Interpretation of Research on Fuel Fragmentation, Relocation, and Dispersal at High Burnup

Date Published: December 2021

The authors would like to acknowledge the five external experts who provided peer review for this RIL. They each offered detailed comments that significantly improved the final product and helped clarify complex concepts presented in the RIL. The authors truly appreciate the time and thought the panel applied to this review.

Figure 9. Posttest gamma scans of IFA-650.9, a high-burnup PWR fuel rod subjected to a LOCA simulation at the Halden reactor (NRC, 2012).

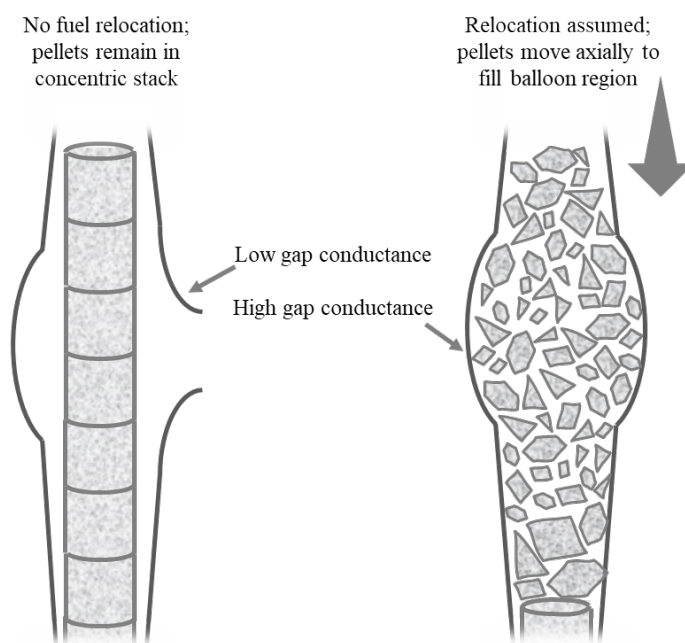
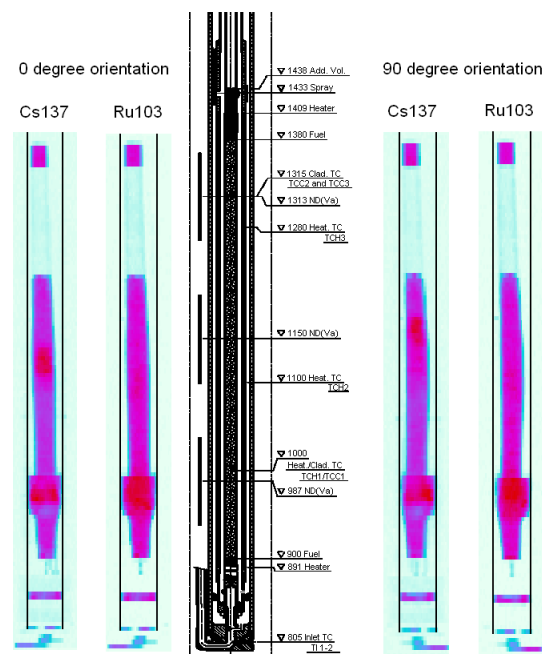
- Reviewers suggested removing references to low and high gap conductivity for cases without and with fuel relocation in Figure 9. This comment was not accepted.

Figure 12. Average packing fraction in the lower portion of the balloon in the SCIP III tests (Magnusson, et al., 2020).

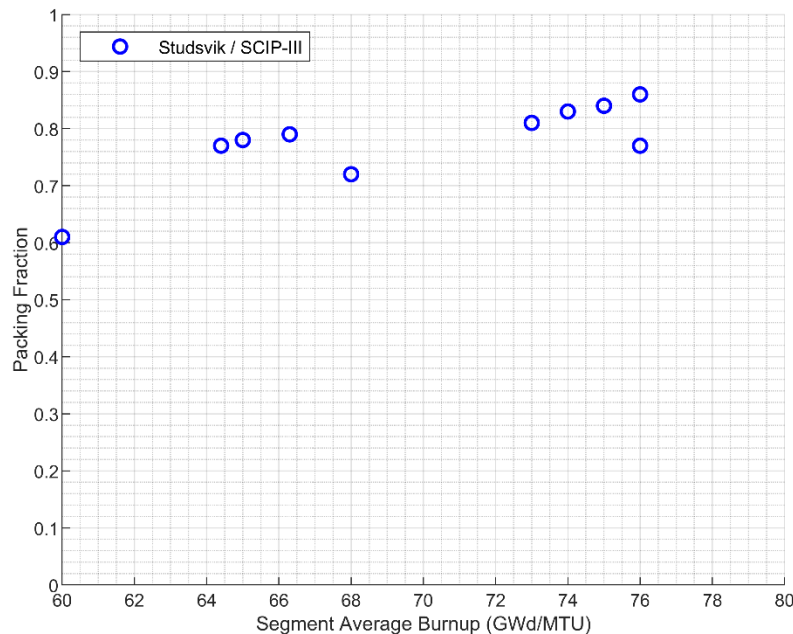
- Reviewers asked for clarification of how the axial distribution of packing fraction in Figure 12 relates to single values of the packing fraction cited for the various tests. This comment was accepted, and discussion was added about the particular test shown in Figure 12.
